**BROOKS HOTEL LOT 6-A
SEVEN-LOT, FOURTEEN-UNIT CONDOMINIUM PROPOSAL AND VARIANCE REQUEST**

STAFF REPORT FOR BOARD OF COUNTY COMMISSIONERS

EXHIBIT A-1

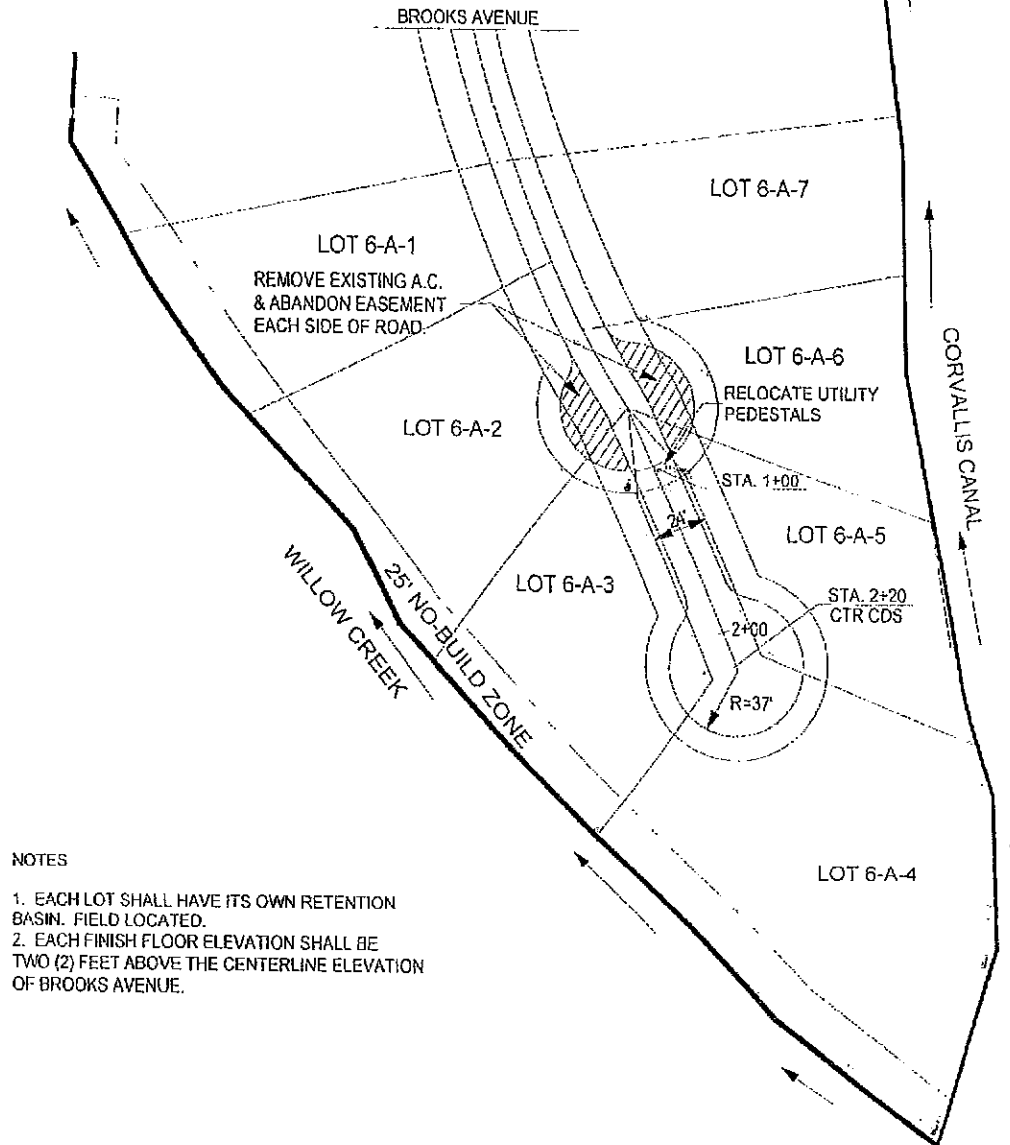
The applicant submitted and received preliminary approval for a set of plans to extend the existing road section and cul-de-sac of Brooks Avenue approximately 150' in length. The applicant is proposing a variance to create what staff has deemed a flag lot in an effort to not have to make any improvements to Brooks Avenue. Should the variance be granted, the applicant would construct a 20' paved driveway from the end of the existing cul-de-sac along the entire length of the stem on the proposed flag lot (150'). Hopefully, this narrative clarifies what is proposed to take place. If more clarification is needed maybe we should try a phone conversation.

Without a more detailed design I can not determine what the difference between the existing and proposed cul-de-sac is. Is there a difference? If not, why was the old one okay and the new one is not? AASHTO states that the "turning area desirably should be circular and have a radius appropriate to the vehicle types expected" and "Minimum outside radii of 10 m (30 ft) in residential areas and 15 m (50 ft) in commercial and industrial areas are commonly used.". The proposal calls for a radius of 37 feet, which would appear to meet the adopted standard and which should provide for a one backing movement turnaround for a 50 feet vehicle.
